# Access Compliance Report

## Public Rights-of-Way

### (Curb Ramps)

Intersection ID: 19935	Main Street: MORRISON_BV	Cross Street: ADAIR_CT	Location: SW
ADA ID: 567413E33F5A	Ramp Type: MedianPerp	Initial Pass/Fail: Fail	Overall Compliance: No
			Severity Score: 26.25

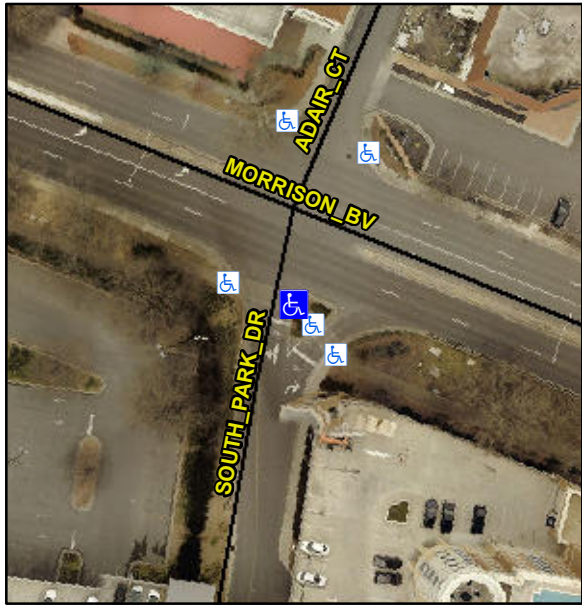
Codes/Mitigation Info/Possible Solution			Field Measurements/Component Compliance					
	Possible Solutions:		Compliance	Description	Data	Compliance	Description	Data
	Remove & Replace Entire Ramp.		N/A	Ramp Length (in)	53.0	No	Ramp Slope (%)	14.5
			Yes	Ramp Width (in)	48.0	No	Ramp XSlope (%)	4.9
			N/A	Flare Type LT	N/A	N/A	Flare Type RT	N/A
			N/A	Flare Slope LT (%)	N/A	N/A	Flare Slope RT (%)	N/A
			N/A	Flare Traversable LT?	N/A	N/A	Flare Traversable RT?	N/A
			N/A	Landing Length (in)	N/A	N/A	DWS Provided?	N/A
			N/A	Landing Width (in)	N/A	N/A	DWS Contrast?	N/A
			N/A	Landing Slope (%)	N/A	N/A	DWS Length (in)	N/A
			N/A	Landing X Slope (%)	N/A	N/A	DWS Full Width?	N/A
Surveyor Notes:		N/A	N/A	Landing Curb? (Y/N)	N/A	N/A	DWS Offset (in)	N/A
PROW/ADA:		R304.2.2, R304.5.3	N/A	Shared Landing?	N/A	N/A	Gutter Slope (%)	N/A
			N/A	Gutter Ponding?	N/A	N/A	Gutter X Slope (%)	N/A
			N/A	Gutter Lip Ht (in)	N/A	N/A	Painted X Walk2?	N/A

N/A	Painted X Walk1?	Yes	N/A	X Walk 2 Direction	N/A
				X Walk 1 Direction	To NW		X Walk 2 Width (in)	N/A
			N/A	X Walk 1 Width (in)	96.0	N/A	X Walk 2 Slope (%)	N/A
				X Walk 1 Slope (%)	0.6		X Walk 2 X Slope (%)	N/A
				X Walk 1 X Slope (%)	0.9		Ramp inside XWalk2?	N/A
			N/A	Ramp inside XWalk1?	Yes	N/A	Clear Space?	N/A
				Road Slope (%)	N/A	N/A	Clear Space to XWalk (in)	N/A
				Road X Slope (%)	N/A	N/A	Storm Grate/Utility Hazard?	N/A
			N/A	Any Obstructions?	N/A	N/A	Storm Grate/Utility Type	N/A
				Obstruction Type				
						N/A		N/A
						Yes	Surface Condition? (G/P)	Good
Total Cost:		\$ 1650.00
